1171BH  
May 2, 2014

**Re: Proposed modification to Salt Ash Sand Extraction Project (MP 07\_0094)**

### **3.1 Acoustic Fence**

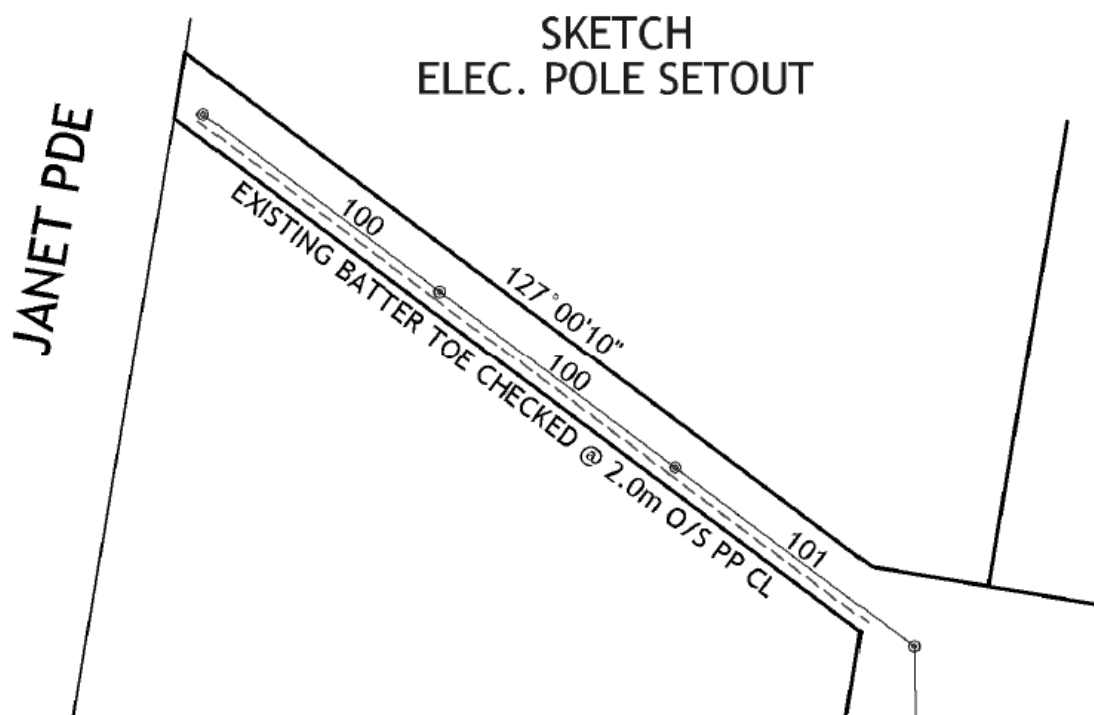
The proposed acoustic fence is 3,000mm high from FGL and of treated pine construction. The attached architectural drawing A-10 Rev A indicates the general construction method. We propose to construct the fence at a minimum distance of 2,100mm from the centre of the recently installed Ausgrid poles. The redline on the below sketch indicates the approximate position of the proposed fence.

Could you please advise if Ausgrid have any objections to the fence being installed in the position proposed above, or if any adjustments need to be made to satisfy your requirements.

The purpose of the easement is to provide clear unobstructed access to Ausgrid assets.

We do not permit any permanent structures to be built in our Easements.

It is a safety issue that compromises clearances.

Project No:	Drawing Title:				Revision No:
							<b>1171</b>	<b>ACOUSTIC FENCING</b>				<b>B</b>

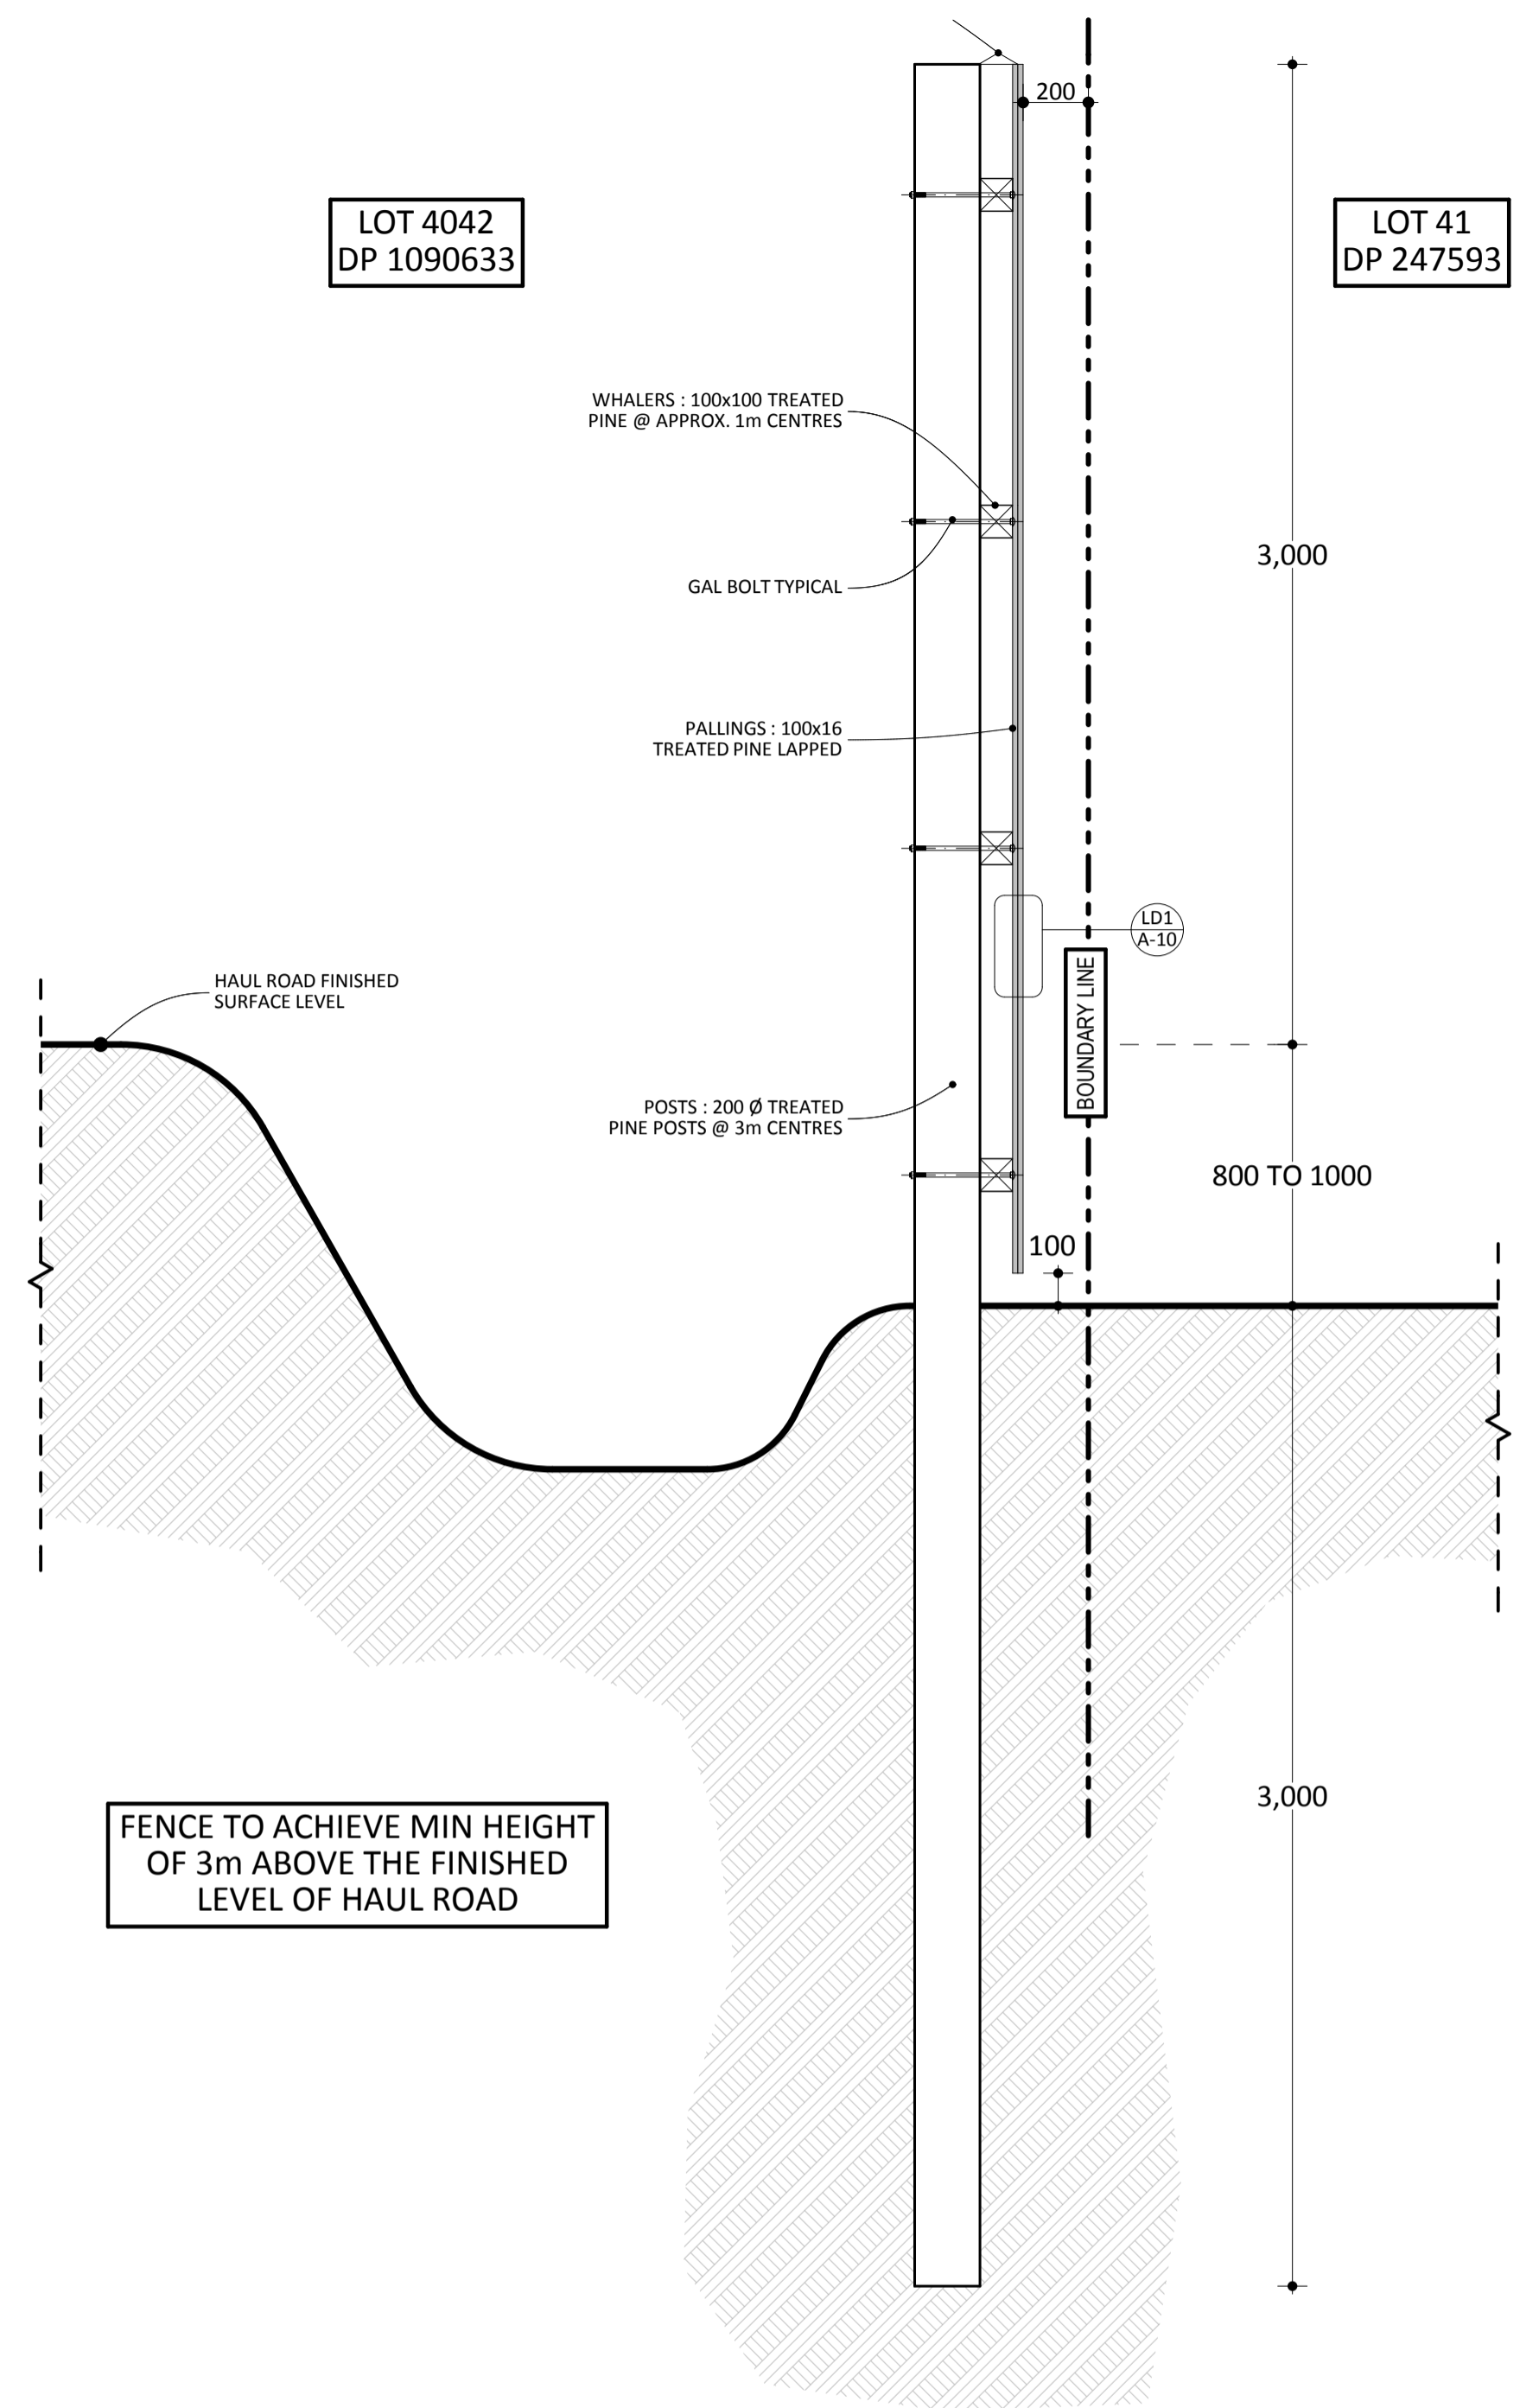
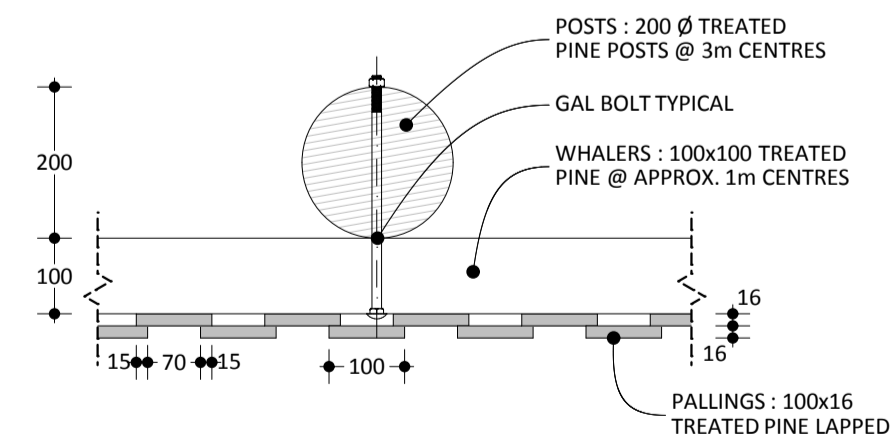
In light of the findings of the *Spectrum Acoustics* report and the current project approval, the company remains committed to providing an acoustic fence along the southern boundary of the haul road. The location of the fence is now, however limited to the common property boundary with Lot 41, DP 247593 which contains receiver JP3. This is detailed in *Figure 2* of the *Spectrum Acoustics* report. As such it is proposed to modify the type of acoustic treatment from a mound and fence to a fence exclusive of the mound. The height of the fence will still be to three (3) metres from the finished surface level of the road. A revised detail is

provided in Attachment D. The company have advised the owners of JP3 of this proposal, who have provided written support for the proposed modification.

Figure 4: Work Areas

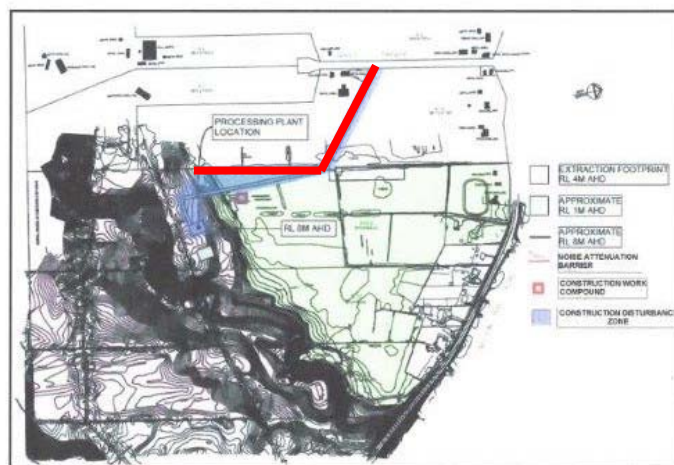
Figure 4 from the Advitech report is reproduced below. It shows an acoustic barrier (as shown in red) that is approximately 600m long.

The location of the barrier as defined in the NMP (from Advitech) appears to have been derived from an (erroneous) interpretation of the results of the original noise assessment (Heggies 2009) the wording from which is also reproduced below;

An analysis of the results from the site noise measurements and a review of the calculations shown in Table 1 indicates that, to ameliorate the measured truck noise, the barrier does not need to extend as far as shown in the reproduced Figure 4.

The NSW Industrial Noise Policy defines a receiver location as being at a residential boundary, or, where the residence is greater than 30m from the boundary, the most affected point within 30m of the residence. Application of this principle, and based on the angle of the access road, indicates that, to achieve compliance with the applicable noise criterion, the acoustic barrier need extend approximately 150m south west from the entrance with Janet Parade (as shown, in red, in **Figure 2**).
